Addendum

Project No: 220937
Project Name: PG-UHN Trayline Assembly System Replacement

Date: March 1, 2023
AD No: 01

MECHANICAL ADDENDUM # 01

A750

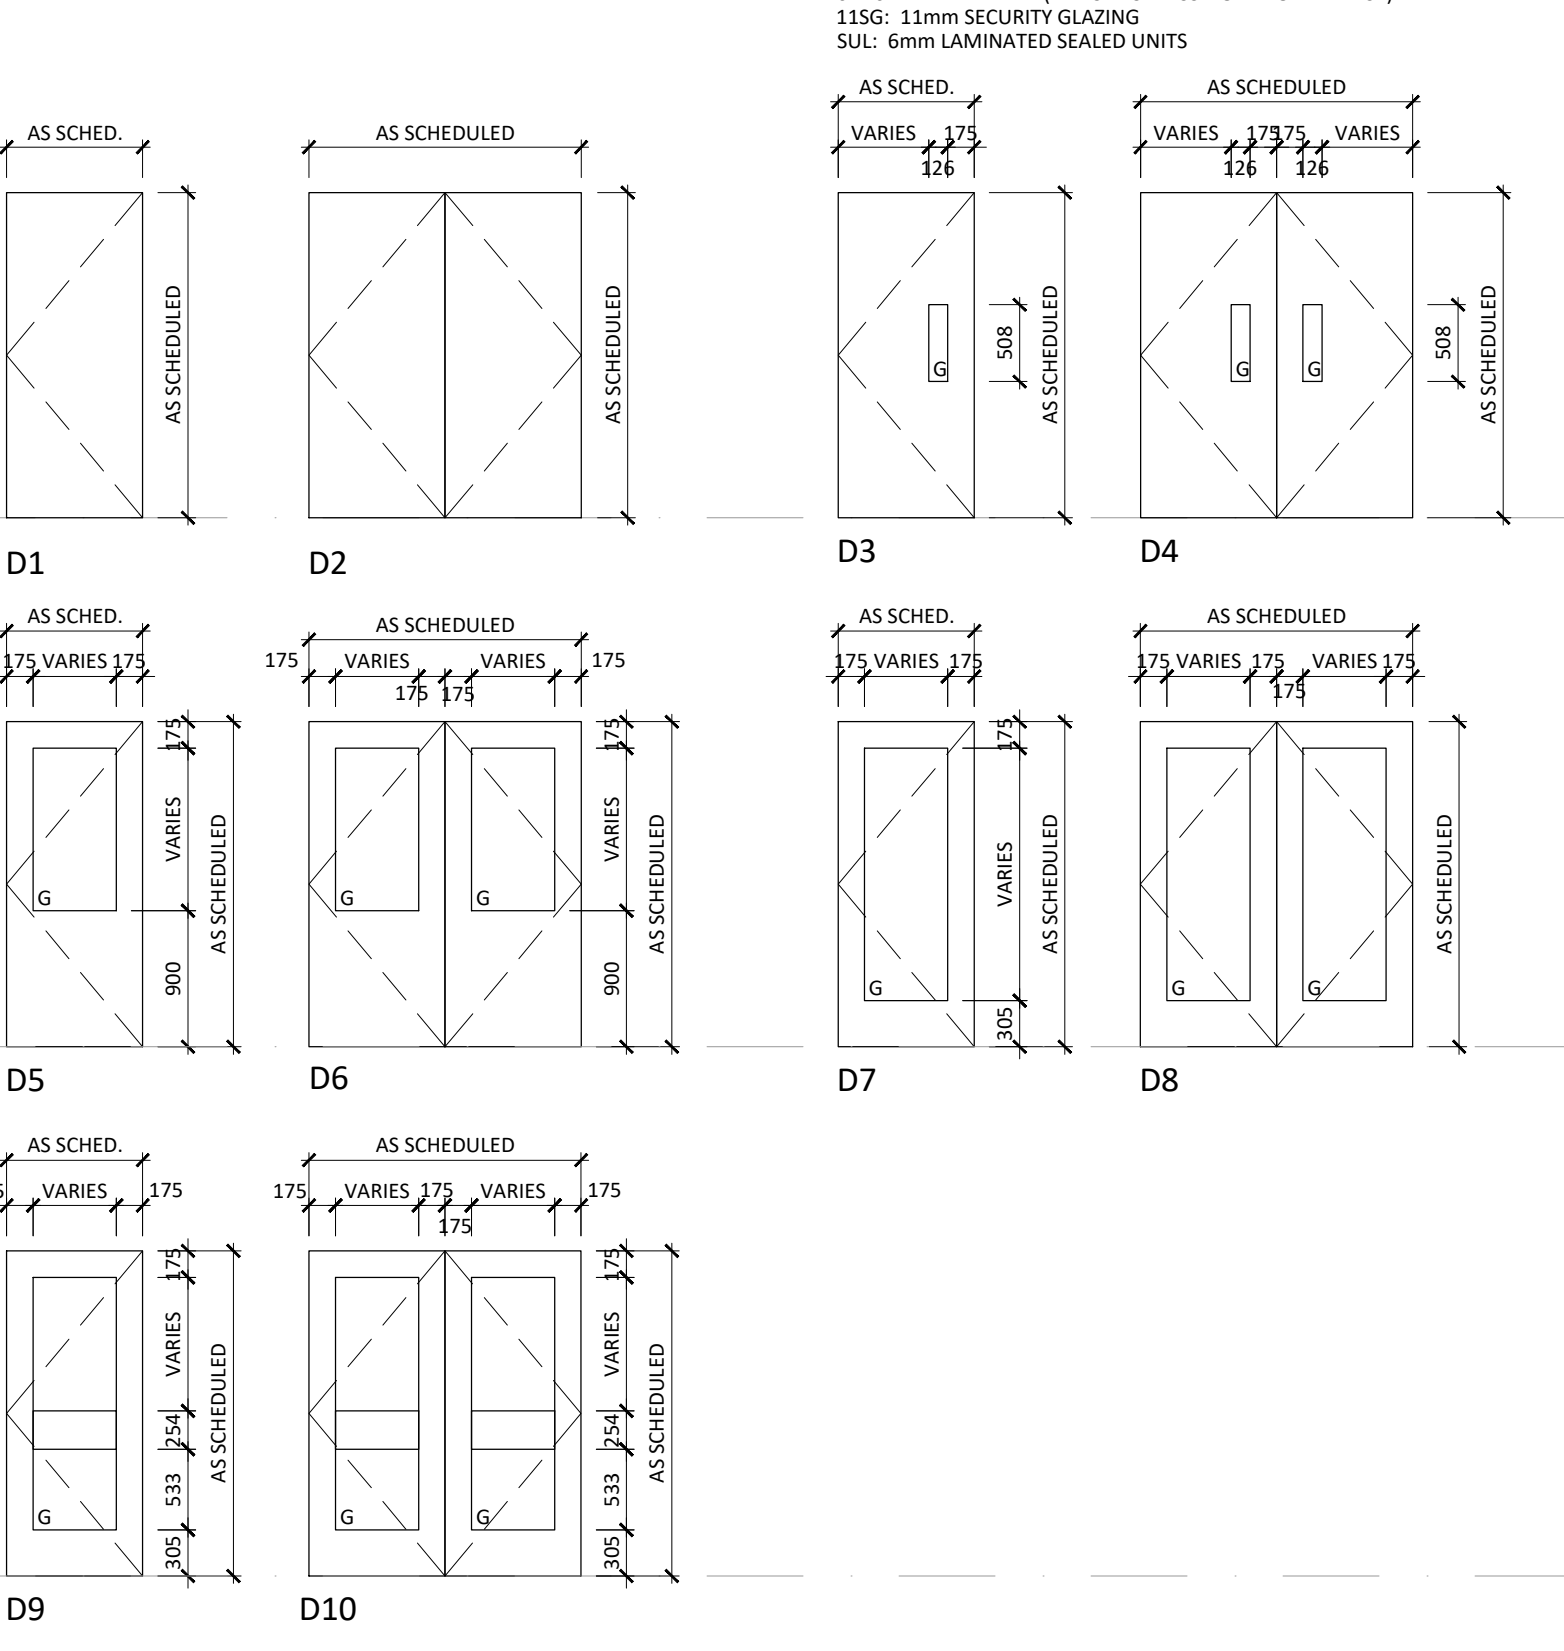
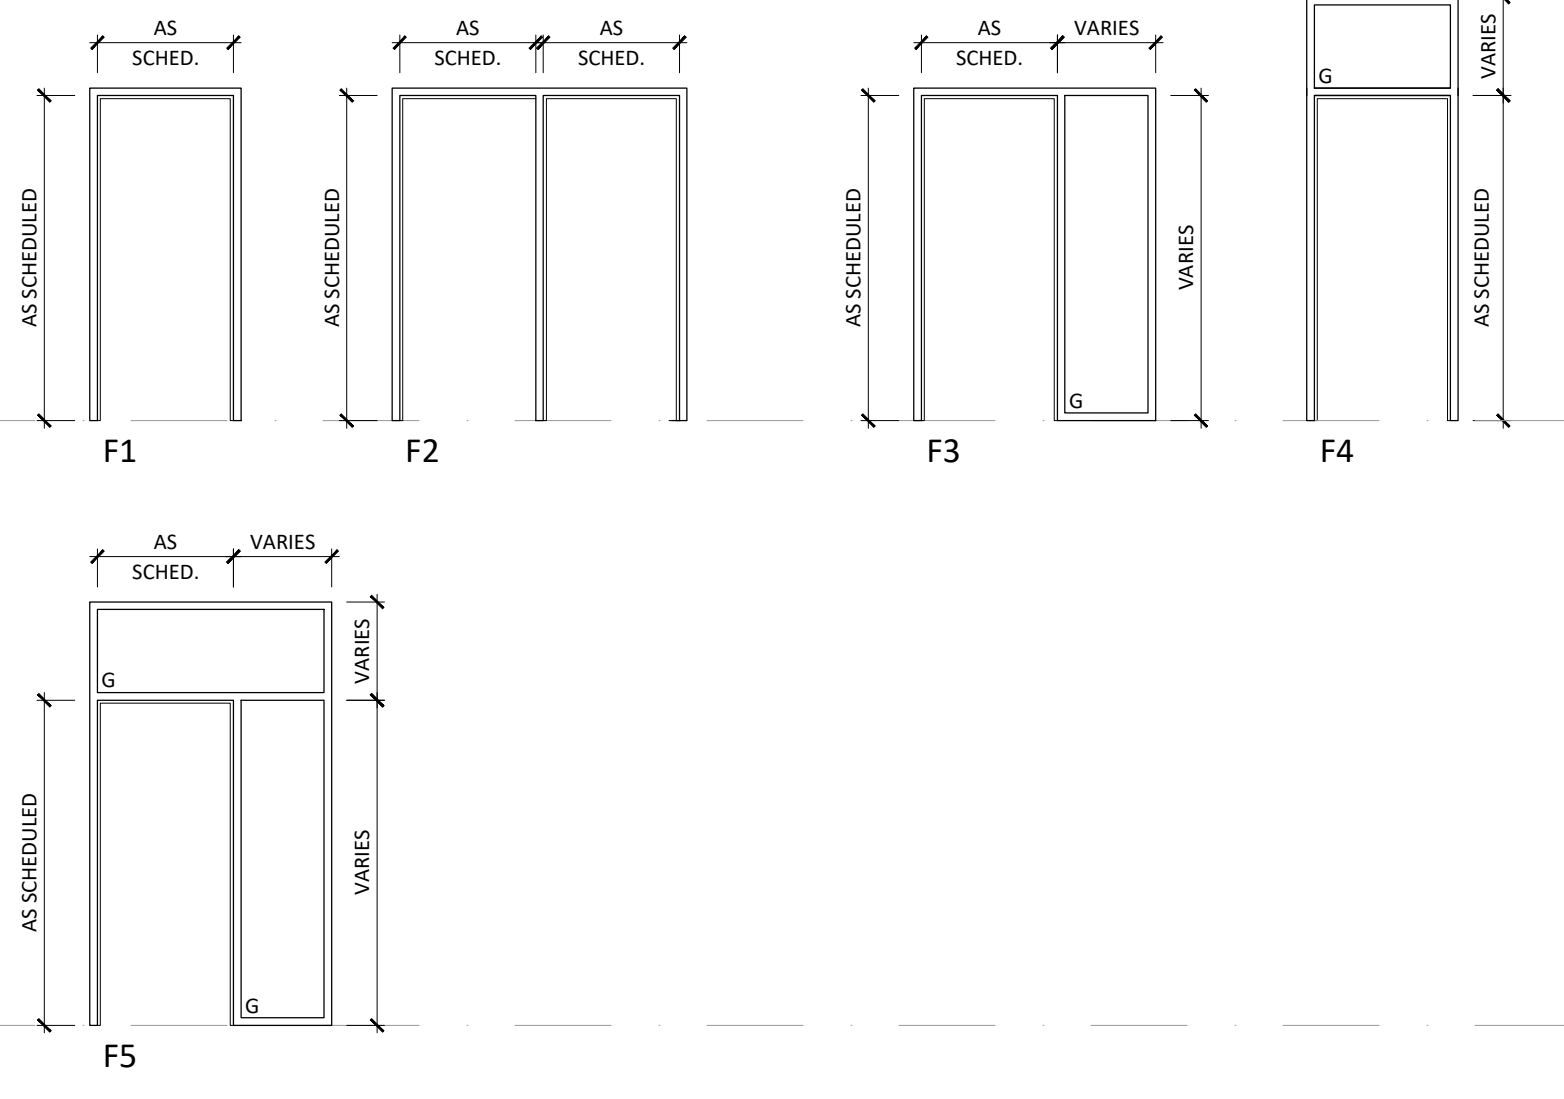
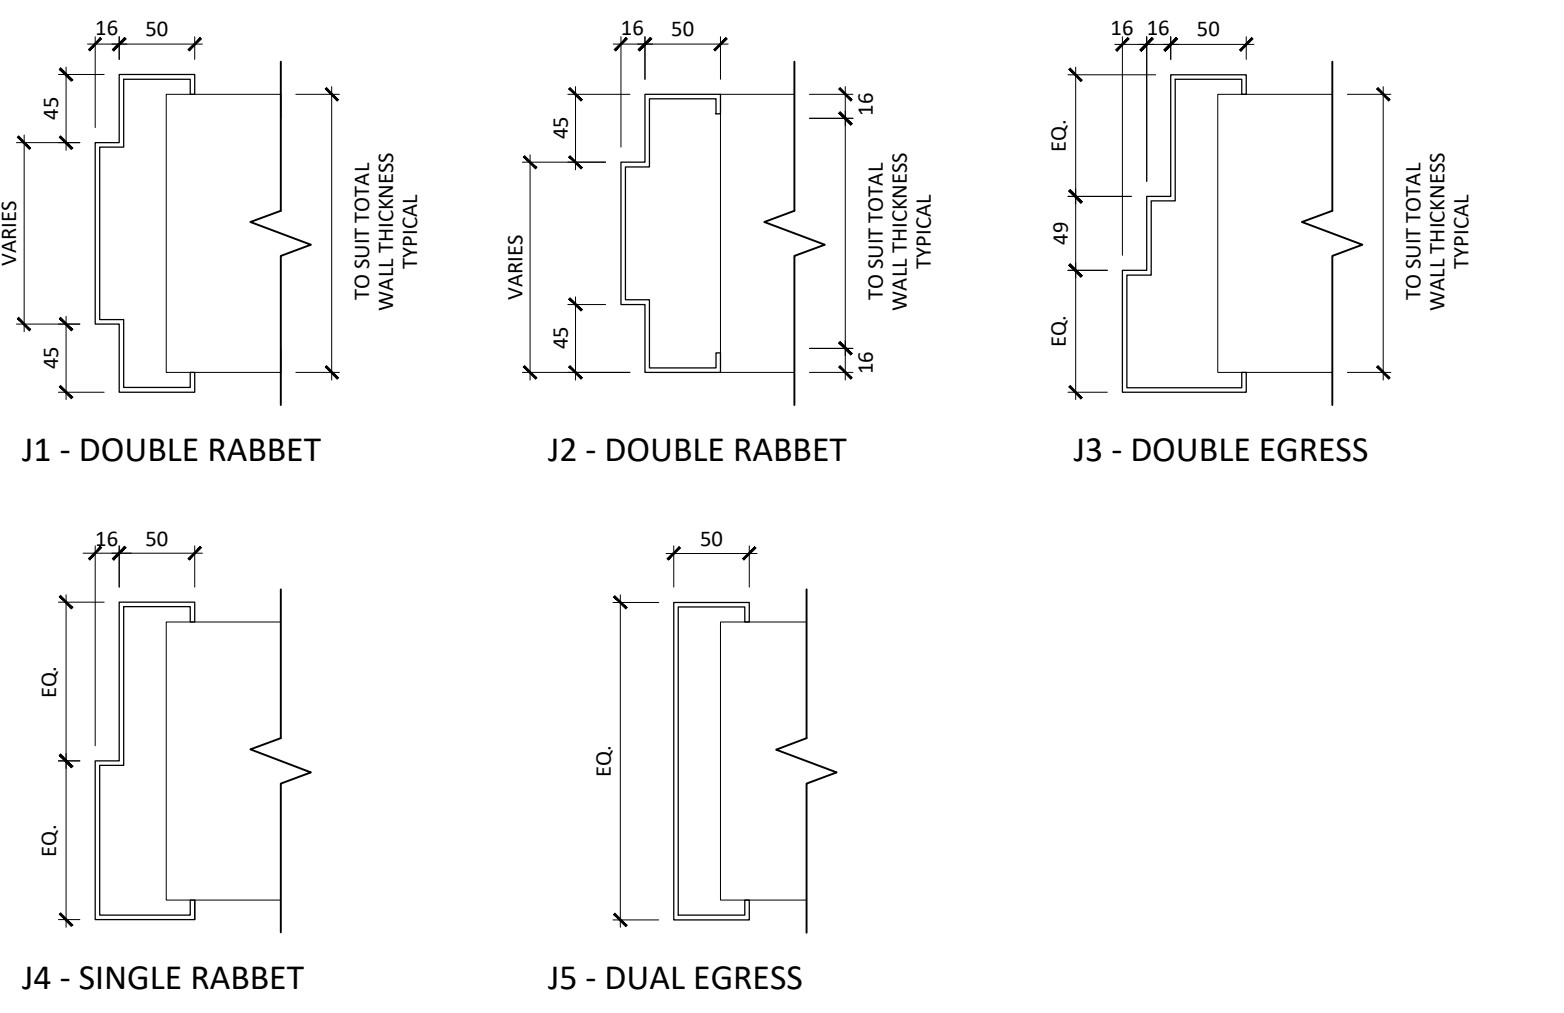
1.2 **Sheet A750 - Schedules**

Finish Schedule Revisions

1.2.1 **PT-1 - Paint Finish**

Manufacturer: Dulux
Product Name: Enduring Ice
Code: DLX1102-1
Finish: Refer to Specification (09 91 00)

1.2.2 **WP-1 - Wall Protection**

Manufacturer: Altro
Product Name: Whiterock
Code: FT41
Finish: Textured Pearl

1.2.3 RB-2 - Resilient Base

Manufacturer: n/a
Product Name: n/a
Size: 152mm
Finish: n/a
Installation: n/a
Notes: RB-2 wall base to be 152mm high VCT to match, as closely as possible, the existing adjacent flooring. Contractor to allow for 2 colours.

Project
UHN TRAYLINE ASSEMBLY SYSTEM
REPLACEMENT
1475 EDMONTON STREET, PRINCE GEORGE, BC, V2M 1S2
Drawing
PLUMBING PLAN - PHASE 1 - LEVEL 0
Sheet Number
22306
M111

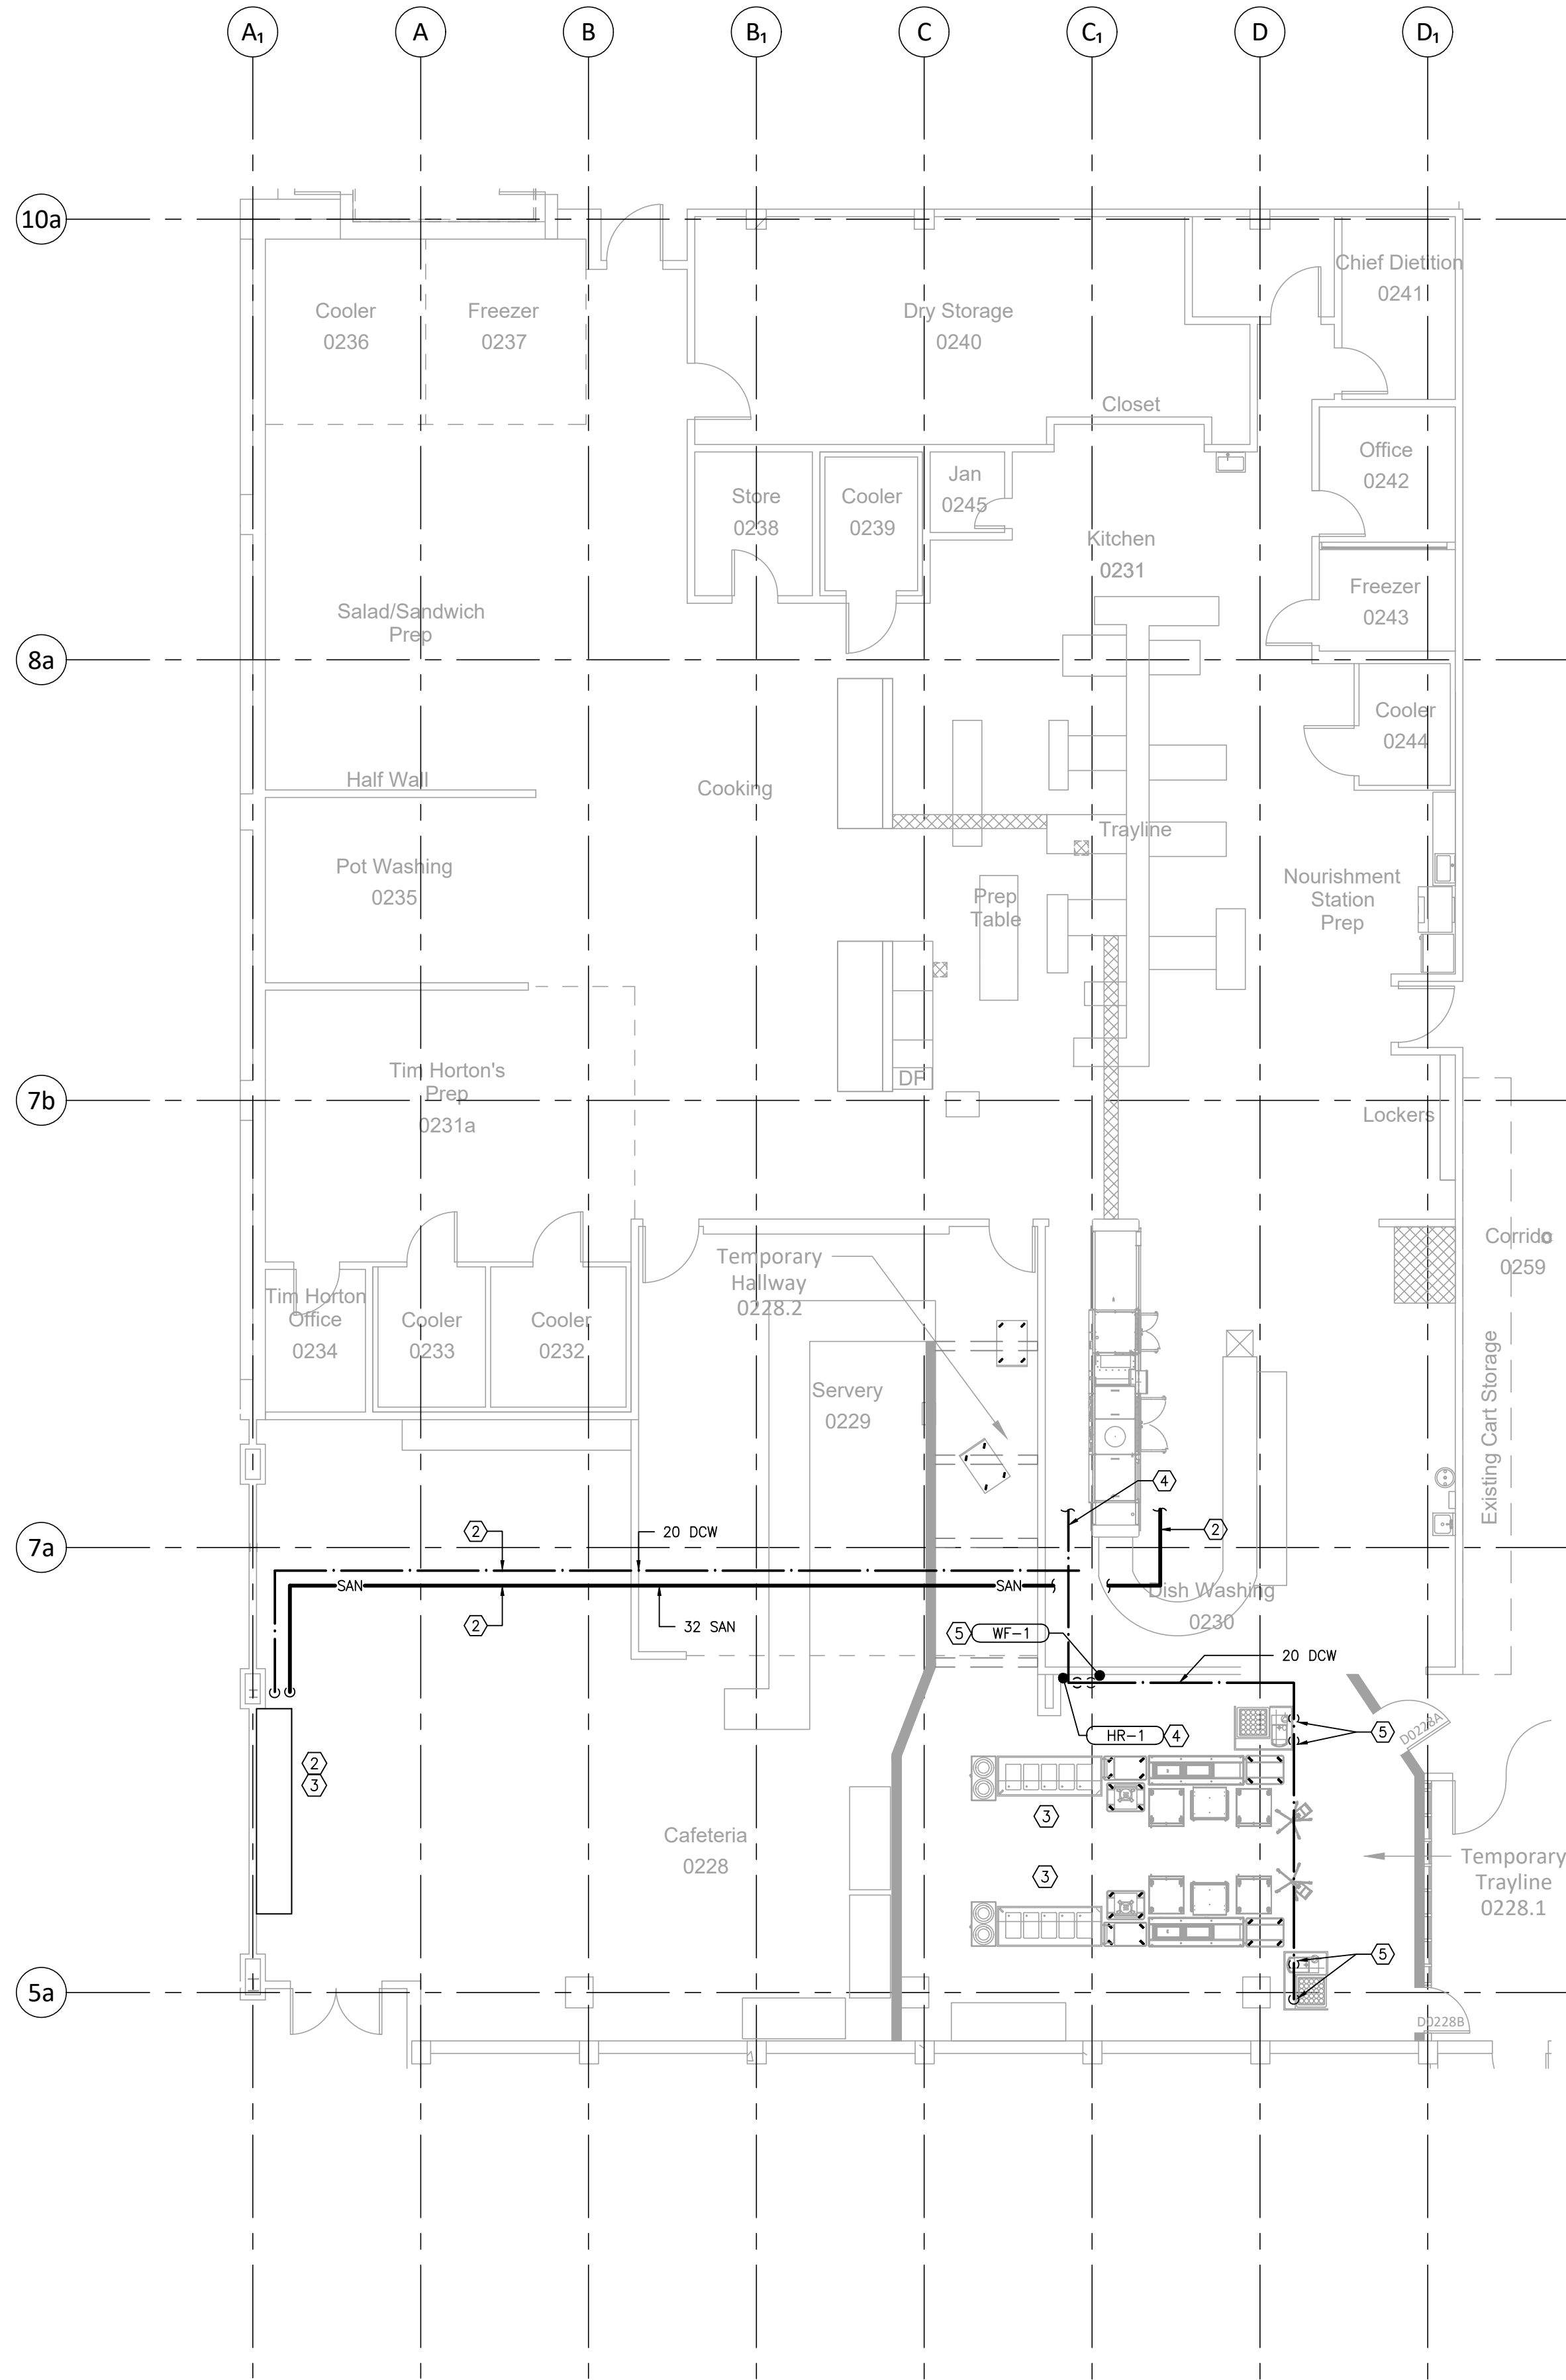
Reference: Mechanical drawings M111, M113 and M400
Delete
 Existing drawings M111, M113 and M400
Add
 Revised mechanical drawings M111 and M400 are reissued. (see attached)
